RE: Equipment Modification
GTSP Truck Loading Station and Baghouse
Permit No.: AC29-175044

Evacuation System Design Changes

FILE NO. _____ JOB NO. _____
G.T.S.P. #4 - PROPOSED TRUCK LOADING & DUST COLLECTION SYSTEM

AC 29-175044: Specific Condition No.1

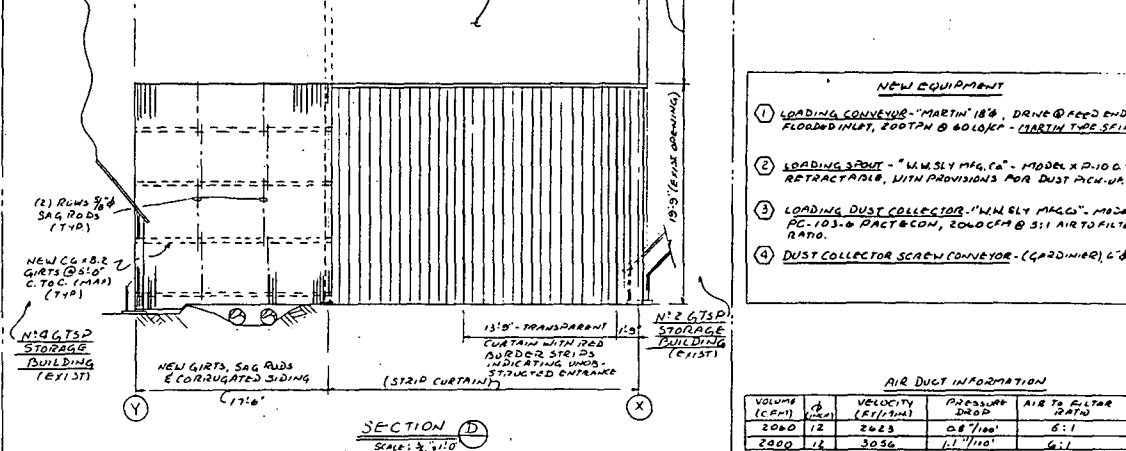
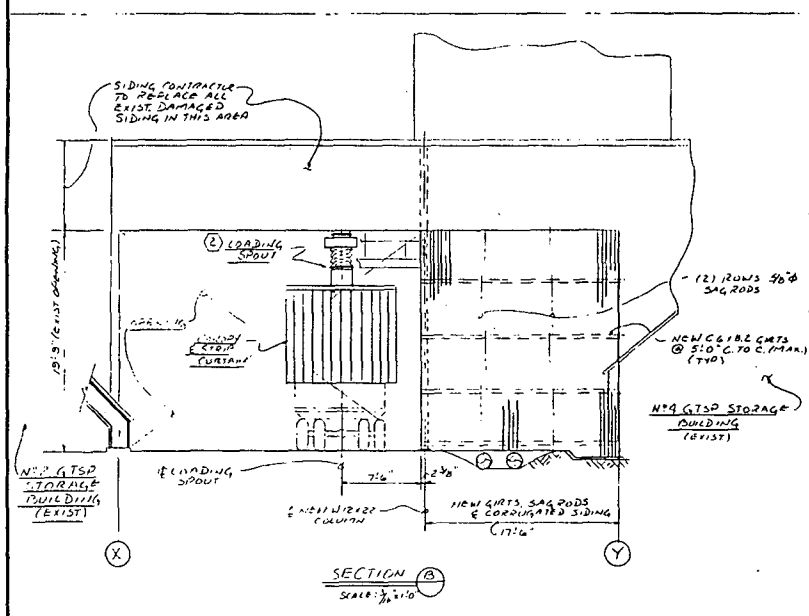
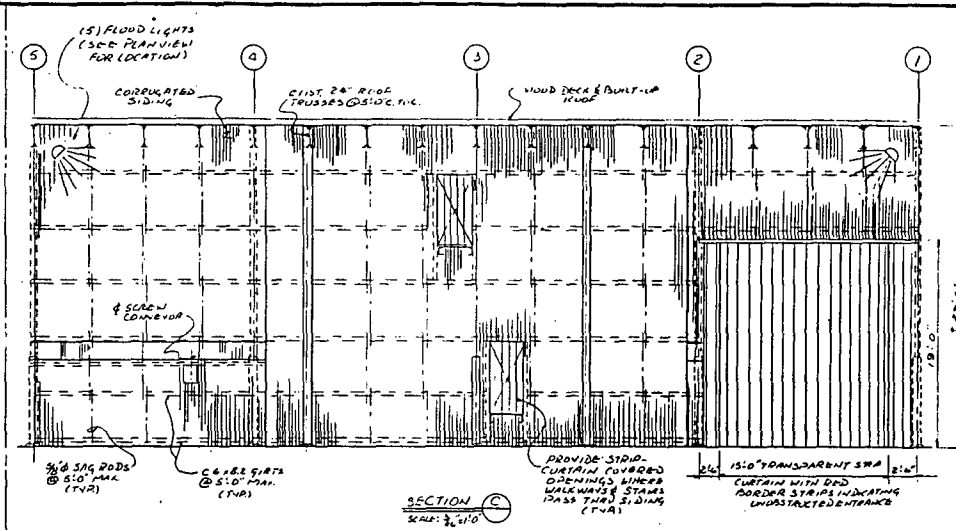
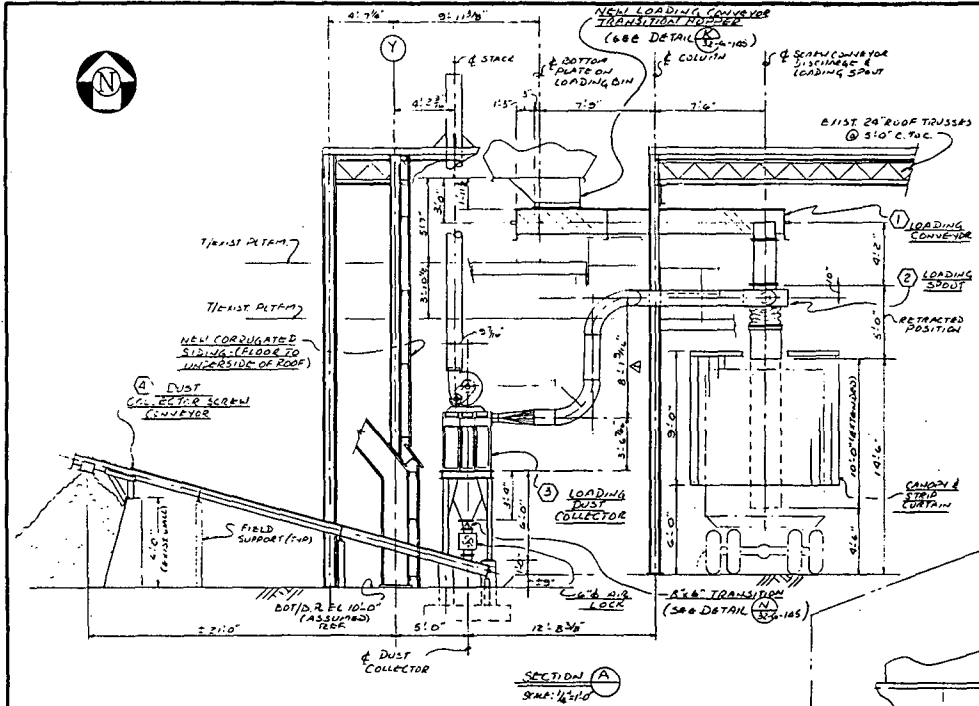
In reference to Permit No.: AC29-175044 for the GTSP Truck Loading Station and Baghouse facility, the following changes in the original evacuation system are submitted:

Fugitive emissions around the truck itself will be controlled by enclosing the top half of the truck-body with a heavy strip curtain. The GTSP product will be delivered to the truck body using the W.W. Sly Retractable Dust Free Loading Spout (Model Number XP10), which is evacuated to a high efficiency bagfilter. The bagfilter is a W. W. Sly Pactecon Model PC 103-6, with a collection efficiency of 99.9 percent for all particles over 1/2 micron. The unit will have the following design parameters:

Stack Height:	35 feet
Stack Diameter	1.25 feet
Air Flow Rate:	2060 acfm
Air to Cloth Ratio:	5:1
Maximum outlet Dust Loading:	0.02 gr/dscf

- NEW EQUIPMENT**
- (1) LOADING CONVEYOR - MARTIN 18", DRIVE @ FEED END, FLOOR MOUNT, 200 T/H @ 80 L/HR - MARTIN TYPE SFL
 - (2) LOADING SPOUT - W.M.S.LY MFG. CO. - MODEL X P-100 S, RETRACTABLE, WITH PROVISIONS FOR DUST INLET
 - (3) LOADING DUST COLLECTOR - W.M.S.LY MFG. CO. - MODEL PC-103-D PACT # CON, 2000 CFM @ 5:1 AIR TO FILTER RATIO
 - (4) DUST COLLECTOR SCREW CONVEYOR - GARDINER L'S

The construction and operation of this source shall be in accordance with the capacities and specifications stated in the application and modified by the permittee's letter dated January 9, 1991 (Attachment No. 2).
